Response to Submissions Report

Mixed-use Development and Infill Affordable Housing

Crown Street, Wollongong

Submitted to Department of Planning, Housing and Infrastructure
on behalf of Wollongong Developments No.8 Pty Ltd

Figure 3 Location of reduced building massing

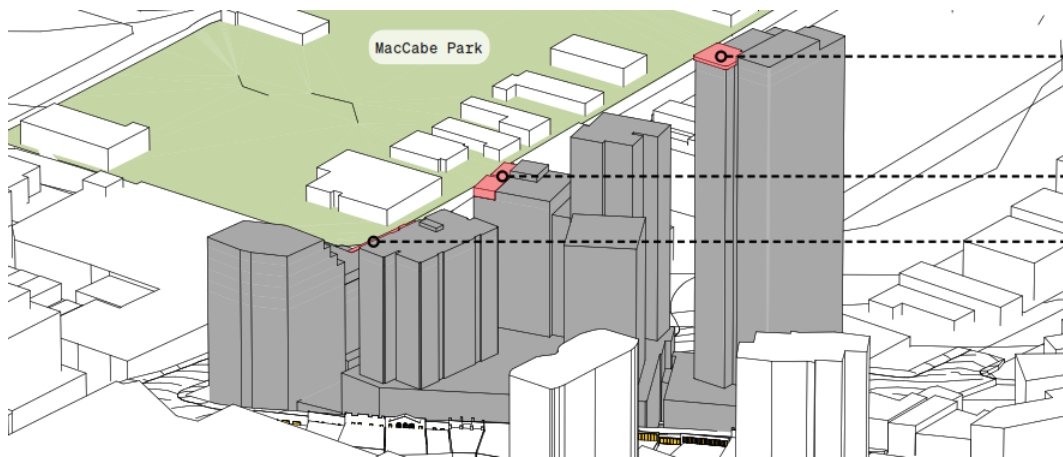
In response to feedback received from DPHI, Citi 1 Owner's Committee and members of the public, the proposed development has been refined to increase the setback at the upper levels of Building 1, Building 2.3 and the Hotel Building to maximise solar access to MacCabe Park, as shown in **Figure 3** and detailed in the sections below.

Figure 5 Comparison between SSDA (as exhibited) previous and proposed Building 2.3 massing from the south elevation

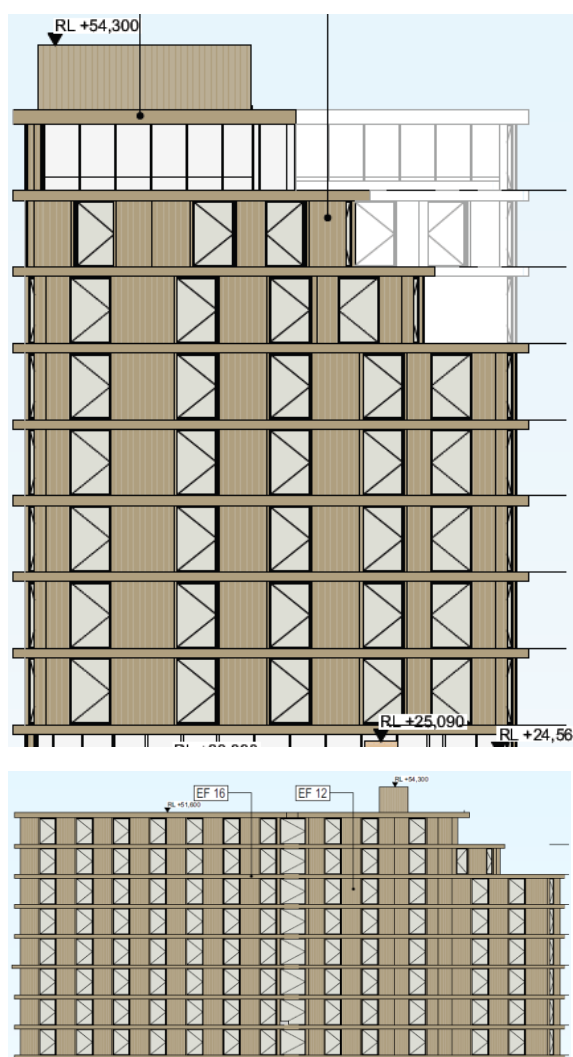
The mass of Building 2.3 has also been reduced, as shown in **Figure 5**. This reduces impacts to environmental amenity by providing a suitable height transition to reduce overshadowing impacts to MacCabe Park. The design changes include:

- A reduction in building height from 17 storeys to 16 storeys, to the eastern portion side of building. This helps reduce the exceeding height, as discussed in the revised Clause 4.6 Variation Request at **Appendix AA**.
- This setback portion of the upper level enables the building to step down to the east resulting in an improved transition in building height.

- The GFA of Building 2 has been reduced by 666m², and the dwelling yield in this building has been reduced by three (3) apartments.

Figure 6 Comparison between SSDA (as exhibited) and proposed Hotel Building massing from south and west elevations

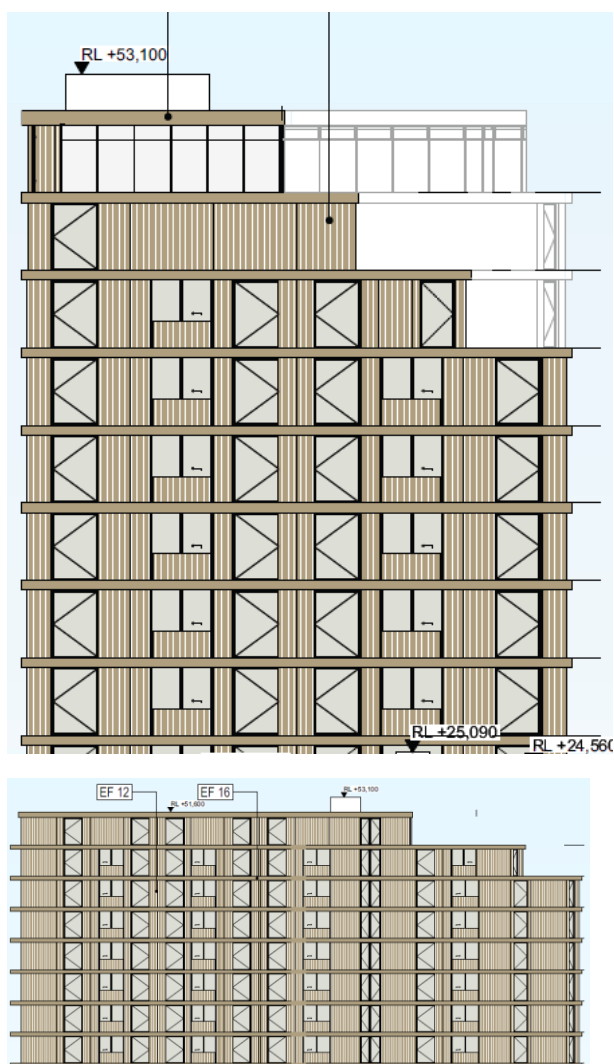
The mass of the Hotel Building has been reduced, as shown in **Figure 6**. This reduces impacts to environmental amenity by providing a suitable height transition to reduce overshadowing impacts to MacCabe Park. Notable design changes which have reduced the mass of the building include:

Figure 7 Comparison between SSDA (as exhibited) and proposed building separation between Building 2.1 and 2.2 above Level 3

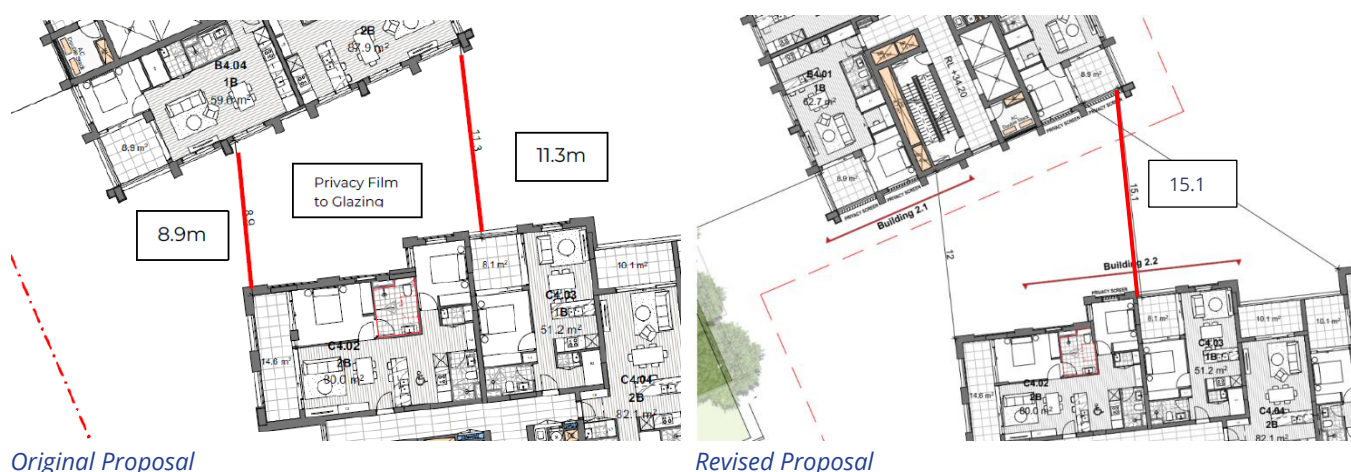
In response to feedback received from DPHI, SDRP and Council, the proposed development has been refined to enhance the visual privacy of apartments by limiting opportunities for overlooking between Building 2.1 and Building 2.2, as detailed in the sections below.

The revised orientation of Building 2.1 has repositioned habitable room windows away from Building 2.2, which addresses potential visual privacy impacts by reducing opportunities for direct overlooking between the two buildings.

The reduction in the setback to Crown Street from 6m to 3m has also facilitated a corresponding increase in the separation distance between Building 2.1 and Building 2.2. As a result, the distance between the buildings has increased from 8.9m to 12m along the western interface and from 11.3m to 15.1m along the eastern interface as shown in **Figure 7** below and as discussed in the revised Clause 4.6 Variation Request at **Appendix BB**. These increased separation distances further mitigate potential overlooking impacts, improve access to daylight and outlook, and contribute to a more generous spatial relationship between the buildings, resulting in enhanced residential amenity and a higher-quality built form outcome.

Figure 8 Privacy measures introduced between Building 2.1 and Building 2.2

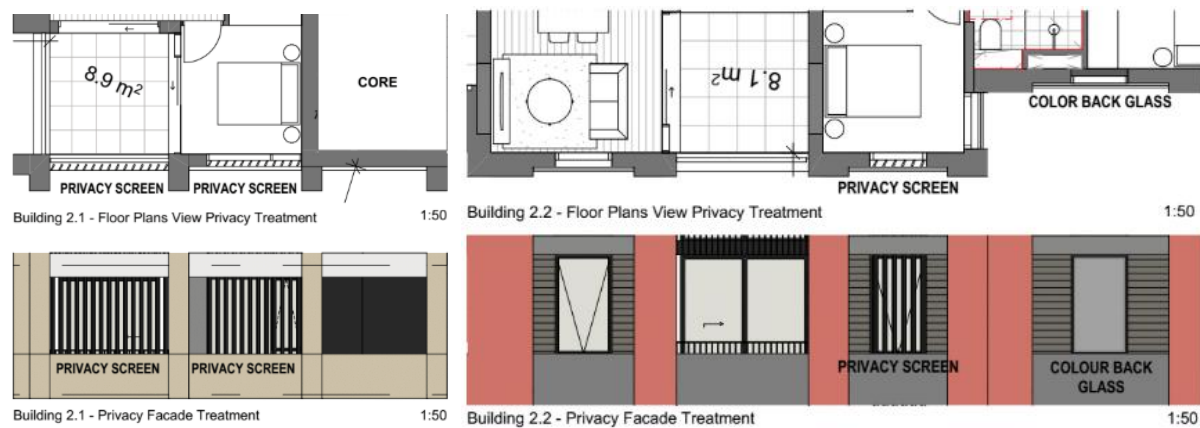
Further privacy measures have been incorporated in Building 2.1 and Building 2.2 to ensure good quality residential amenity outcomes. These measures include the provision of privacy screens to habitable room windows and balconies, as shown in **Figure 8** below, which will limit opportunities for overlooking between dwellings and neighbouring buildings. Together with the increased building separation distances and reorientation of windows, these treatments enable visual privacy to be achieved for residents while maintaining access to outlook, daylight and ventilation. As a result, the development achieves an appropriate balance between residential amenity, building design quality and occupant privacy.

Figure 9 Comparison between SSDA (as exhibited) and proposed Marcus Clark Building activation at Lower Ground Level

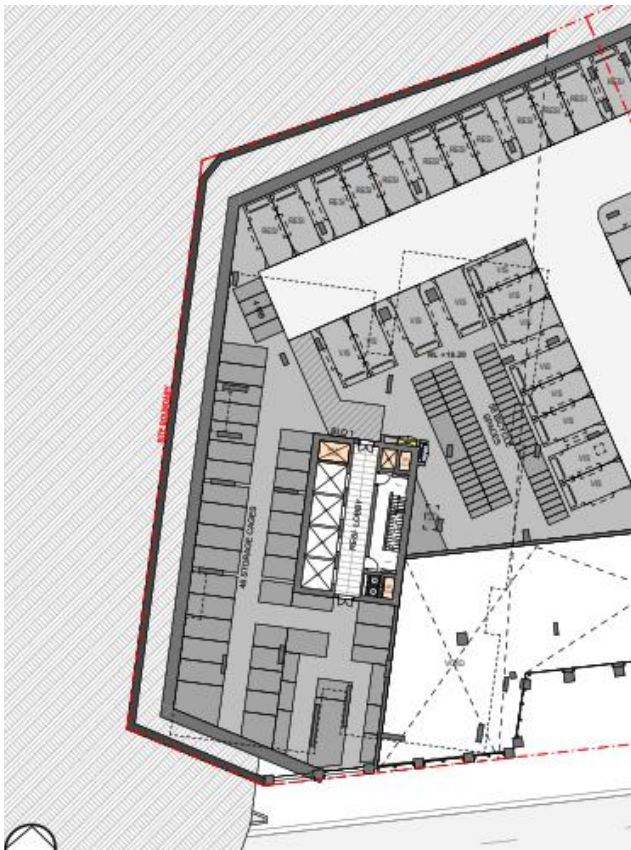
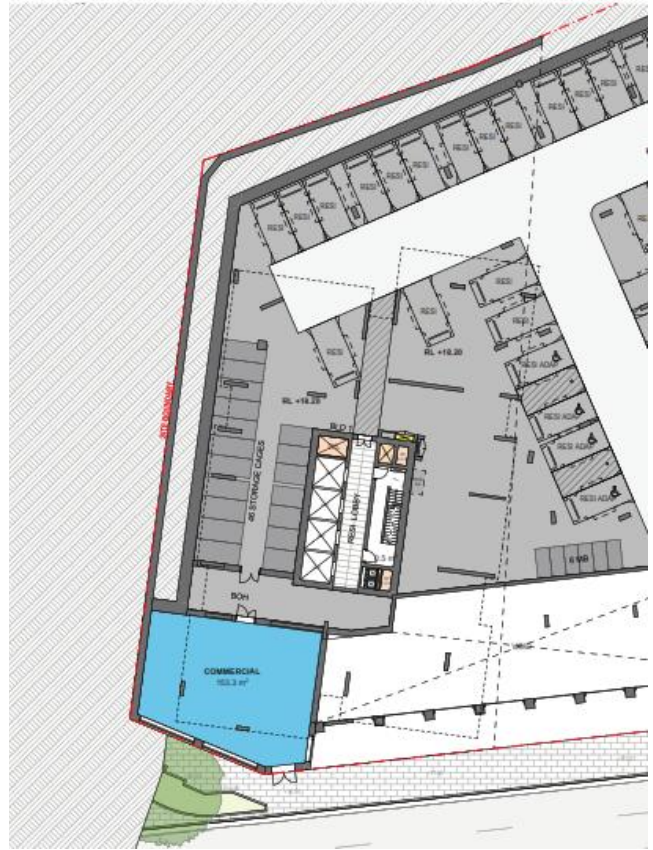
At Lower Ground Level, the commercial tenancy previously located above street level at the corner of Burelli Street and Atchison Street has been relocated to the Burelli Street frontage, providing direct access from the public realm. This change increases the visibility and accessibility of the tenancy, promotes pedestrian activity along the street, and contributes to a more active and engaging streetscape. Refer to **Figure 9** below.

Figure 13 Comparison between SSDA (as exhibited) and proposed east-west through-site link at Lower Ground Level

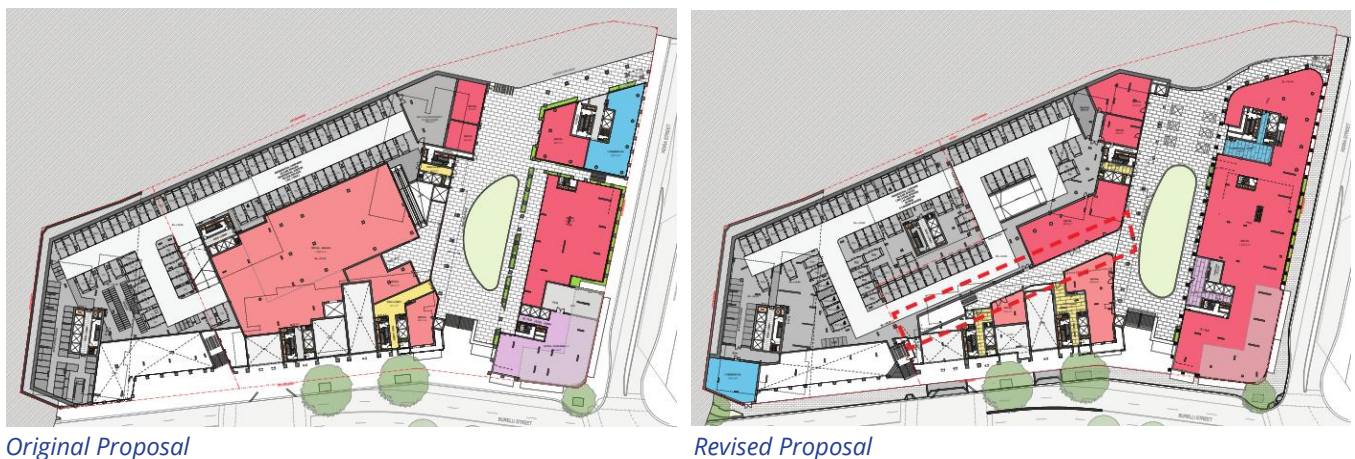
A new east-west through-site link has been introduced as part of the revised design to enhance permeability, connectivity and pedestrian movement across the site, as shown in **Figure 13** below.

The proposed through-site link will be 4.5 m wide along its entirety, with a double-height clearance of 6m from the plaza level and 3m from the laneway level. To ensure safe access and movement through the site in accordance with CPTED principles, the through-site link will be gated and closed outside of normal business hours (8am – 6pm). The through-site link is designed to be safe, accessible and visually attractive, with active frontages and passive surveillance opportunities that enhance the pedestrian experience and foster a greater sense of place. The introduction of this connection not only improves accessibility and convenience for building occupants and visitors but also delivers a broader public benefit by strengthening east-west connectivity and promoting a more vibrant and connected public realm.

Figure 14 Comparison between SSDA and proposed corner of Atchison Street and Burelli Street

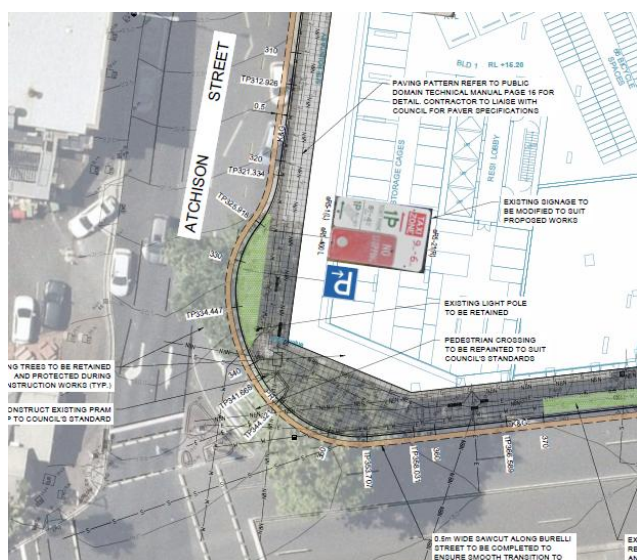
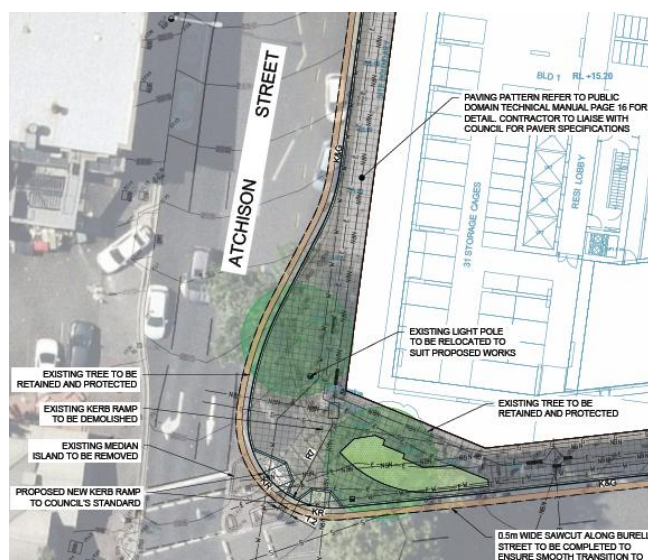
The proposal includes the removal of the existing left slip lane from Atchison Street into Burelli Street, with the kerb line adjusted accordingly. The existing zebra crossing and pedestrian refuge island will also be removed, with the left-turn movement incorporated into a signalised intersection arrangement, consistent with DA-2021/957. Refer to **Figure 14** below and the Updated Public Domain Plans at **Appendix V**.

Figure 15 Comparison between SSDA and proposed Crown Street bus zone

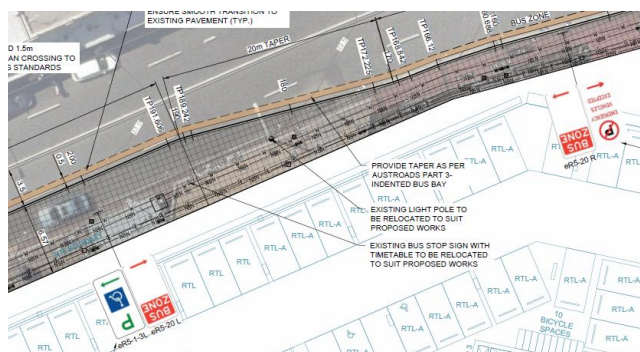
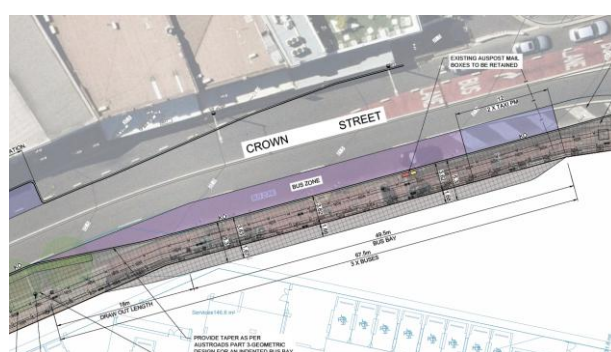
The bus zone along Crown Street is amended to address the TfNSW requirements for length, specifically increasing the bus zone to 55.5m, with an increased bus bay length of 49.5m and a reduced taper of 18m. Refer to **Figure 15** below and the Updated Public Domain Plans at **Appendix V**.

The Updated Traffic Impact Assessment at **Appendix M** includes revised swept path analysis demonstrating the operation of the bus zone.

Figure 16 Comparison between SSDA and proposed Crown Street kerb alignment

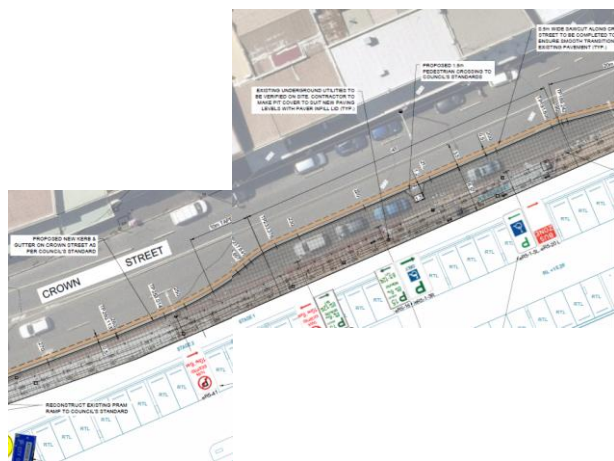
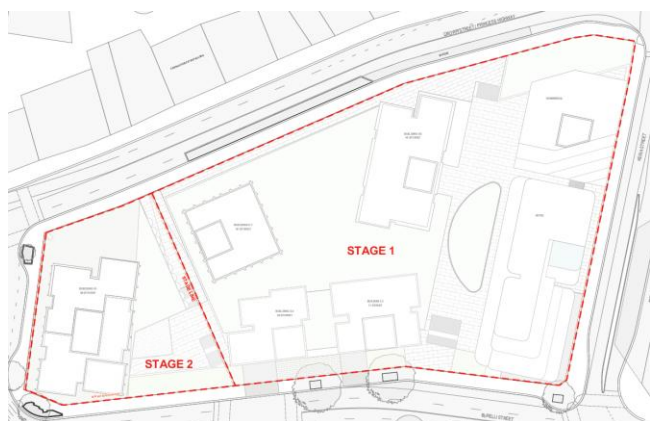
The proposal includes amendments to widen the kerb on both sides of Crown Street and reduce the length of the pedestrian crossings to improve safety. Refer to **Figure 16** below and the Updated Public Domain Plans at **Appendix V**.

Figure 22 Comparison between SSDA and proposed overshadowing of MacCabe Park at 2pm mid-winter

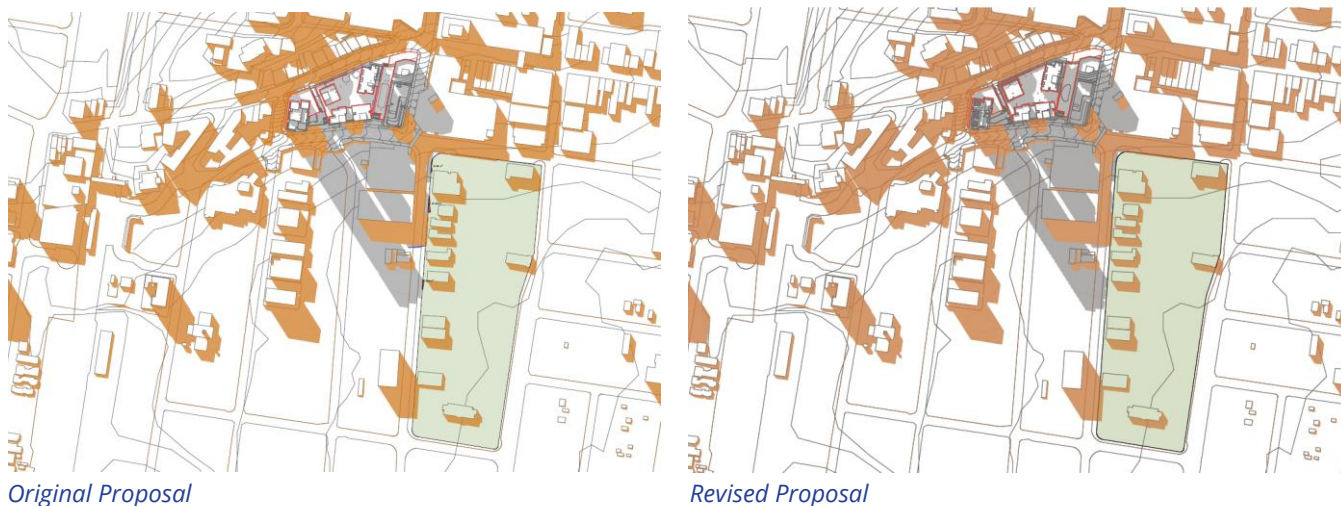
As discussed in **Section 3.2.1**, increased upper-level setbacks have been incorporated into Building 1, Building 2.3 and the Hotel Building to minimise built form impacts and maximise solar access to MacCabe Park located to the south-east of the site. By stepping back the upper levels of these buildings along their eastern elevations, the extent of built form facing the park has been reduced, resulting in reduced shadow impacts.

As a result of the reduced building massing, the revised proposal no longer casts additional shadow over MacCabe Park at 2pm during mid-winter, as shown in **Figure 22** below. This design response represents an improvement from the original proposal and enhances the usability, comfort and amenity of this important public open space, while balancing the development objectives of the site.
